## Tres Suenos Unit Seventeen (REVISED)

City of El Paso — City Plan Commission — 9/20/2018 SUSU18-00074 — Major Combination

**SUMMARY OF REQUEST:** The applicant proposes to subdivide 23.13 acres of land into 103 single-family residential lots, one 1.74-acre park and one 2.53-acre storm-water pond. The proposed subdivision lies within the Tres Suenos Land Study, which was approved on March 22, 2006. This application was approved on a preliminary basis by the City Plan Commission on May 31, 2018, however, it is now being resubmitted as a major combination due a subdivision boundary change. This subdivision is being reviewed under the former subdivision code. Access to the proposed subdivision will be provided via GR Campuzano and Mark Avizo.

1 600 - 100 7. PRELIMINARY PLAT

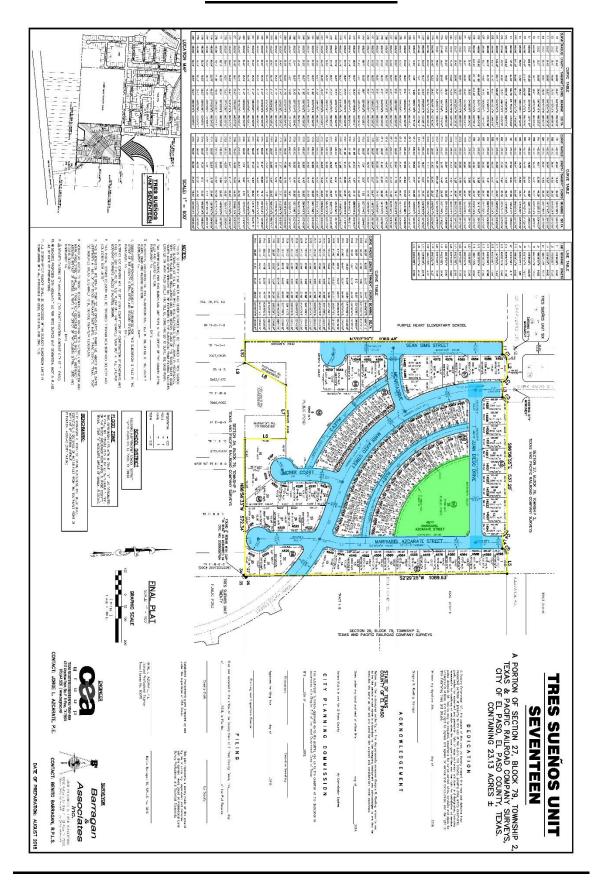
- Ensure that the subdivision improvement plans match the plat and all the proposed crosssections.
- Revise the preliminary and final plat drawings to ensure that the lots abutting the alleys reflect the 5' easement and 20' alley as proposed on the alley cross section prior to recording the plat.

- The 5' easement adjacent to the alley should be included in the dedication statement on the final plat.
